# Groundwater Application Review Summary Form

Application # G- 19426

TO: Water Rights Section Date 2/18/2026
FROM: Groundwater Section Stacey Garrison Reviewer's Name
SUBJECT: Application G- 19426 Supersedes review of 11/27/2024 Date of Review(s)

A. GENERAL INFORMATION: Applicant's Name: Kraemer Farms LLC County: Marion

**Water-Level Measurements in Nearby Wells**

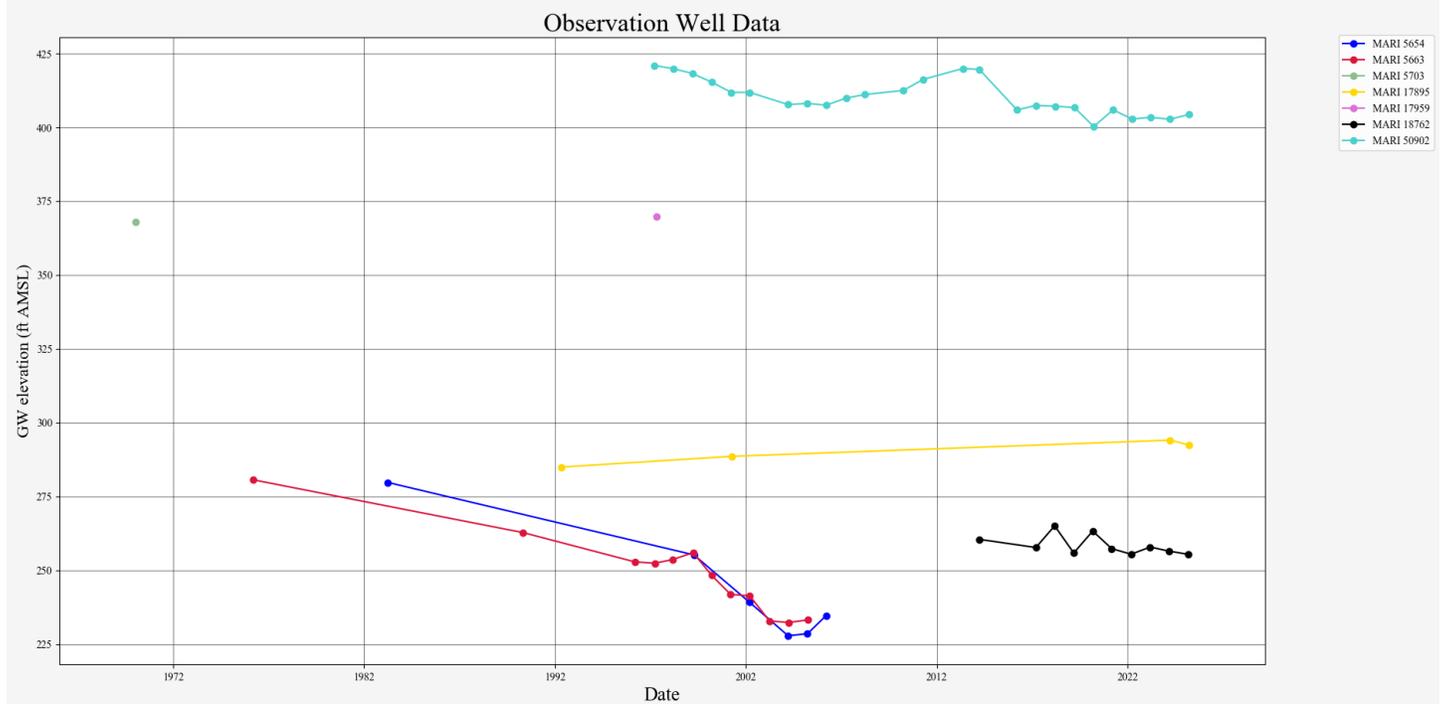
Groundwater level data in this area (within 1.5 miles) is limited to 7 wells that obtain water from the CRBG aquifer. Hydrographs for these wells indicate that water levels are declining (see attached Water-Level Measurements in Nearby Wells). Permits issued for nearby POAs which obtain water from a CRBG aquifer contain the standard condition requiring curtailment of pumping when water levels have declined 15 ft or more; any permit pursuant to this application would be conditioned similarly. MARI 50902 is the closest well with a long-term water level record and likely obtains water from the same groundwater reservoir as the proposed POAs. Water levels in MARI 50902 have declined 16 feet between March 1997 and March 2025. Water level records for several other wells in the area (e.g. MARI 5654, MARI 5663, MARI 18762) show declines that are approaching or are greater than 15 ft. Declines from the reference level defined for POA 1/Well 1 (MARI

**17225) are anticipated to exceed the threshold under standard conditions for CRBG wells in the Willamette Basin, therefore, the proposed use is not within the capacity of the resource.**
